# UNITED STATES PATENT AND TRADEMARK OFFICE

10/521,541

Koang-Ho Jo

## **DETAILED ACTION**

**Figure 1: Johnson, US 3,242,769**

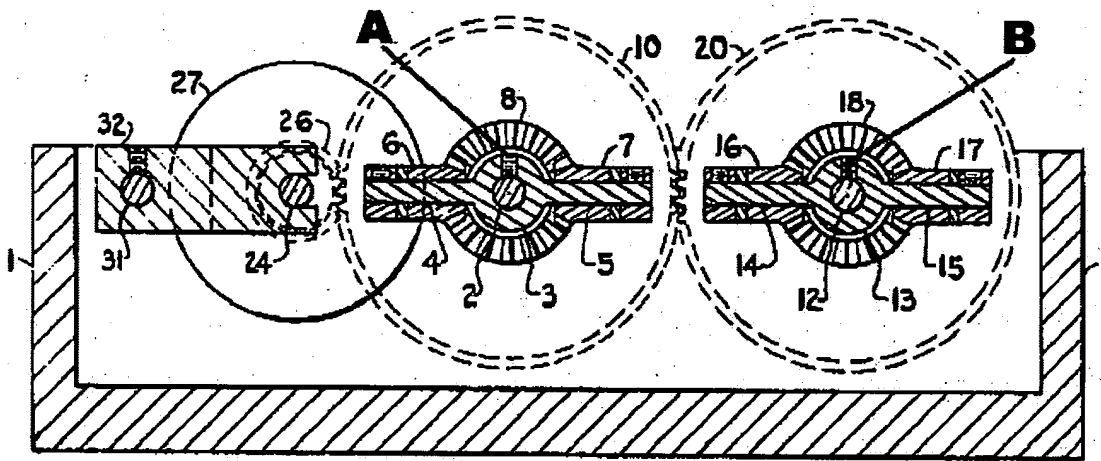
Johnson shows in figure 2 a transmission comprising a main shaft (3) and an auxiliary shaft (13), each formed with a shaft groove in the center, (shown in figure 1 below by reference letters (A, B), which have been added by the examiner), and hollow parts pointed out by reference numbers (2, 12), control gears (6, 7, 16, 17) having power distribution elements (teeth), a control casing (1) having control levers (38), first to fourth ring gears (10, 11, 20, 21) having a transmission rate (gear ratio) as transmission varying elements, first to fourth side gears (8, 9, 18, 19) attached to the ring gears, and first (26) and second (29) idle gears, wherein a casing (1) supports the main shaft (3) and auxiliary shaft (13), and the first (26) and second 29) idle gears.

The grooves (A, B) formed in the centers of the main shaft and the auxiliary shaft are positioned on a same line with the control gear shafts which are orthogonal to the main and auxiliary shafts.

On one side, the main shaft and the auxiliary shaft are engaged with the first (10) and third (20) ring gears, along with the first idle gear (26), representing a low speed gear ratio and, on the other side the main shaft and the auxiliary

shaft are engaged with the second (11) and fourth (21) ring gears, along with the second idle gear (29), representing a high speed gear ratio. The first (10) and third (20) ring gears are engaged with the first (8) and third (18) side gears to be engaged with the control gears (6, 7, 16, 17). The second (11) and fourth (21) ring gears are engaged with the second (9) and fourth (19) side gears to be engaged with the control gears (6, 7, 16, 17).

Johnson does not teach unidirectional clutches being provided on both sides of the main shaft and the auxiliary shaft.
